1955 Corvette: Service Bulletin: Oil Level Gauge Dipsticks

Model and Year: 1955 Powerglide Transmission

Bulletin No: DR-181

POWERGLIDE TRANSMISSION DIPSTICK MARKINGS

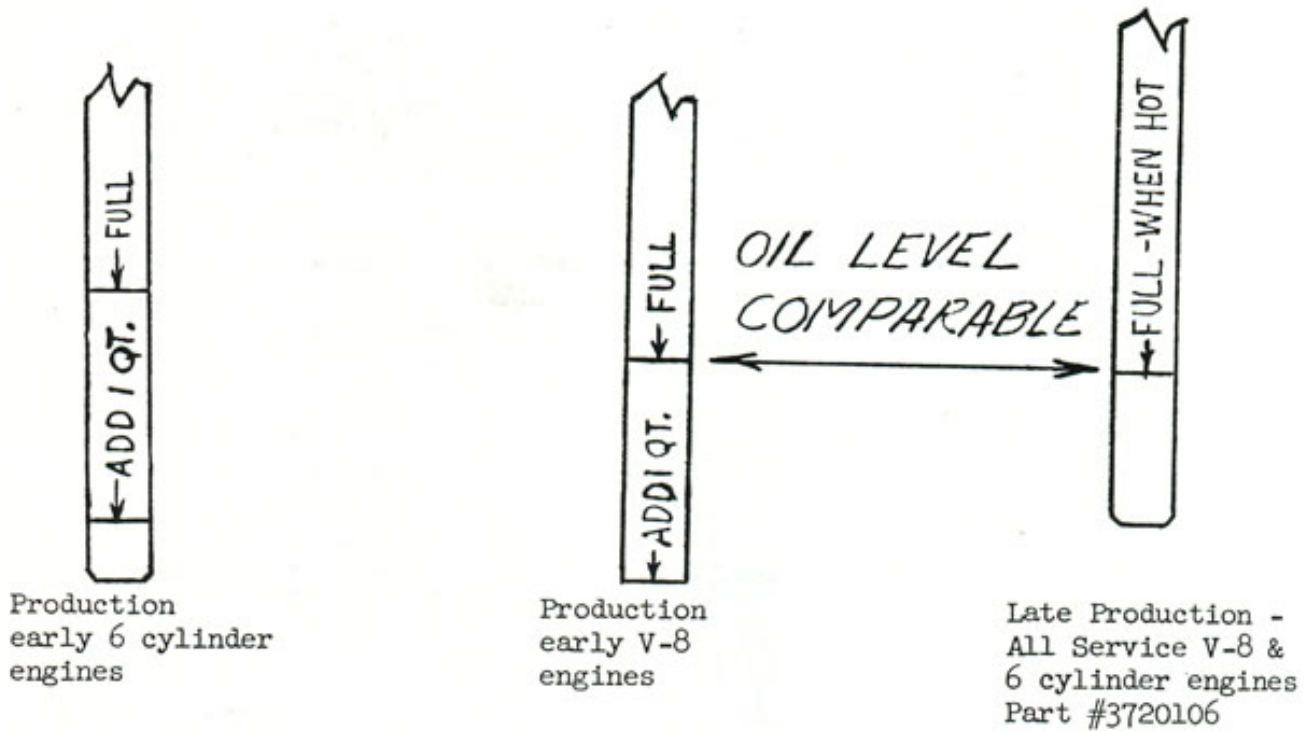
The following sketch shows the various Oil Level Gauge Dipsticks used with the 1955 Powerglide Transmission.

Overfilling the transmission may cause lubricant loss at the Filler.

1. Engine should be idling.
2. Transmission control lever should be in the "N" position.
3. Transmission oil should be HOT.
4. Use the correct dipstick.
5. Check the level accurately.
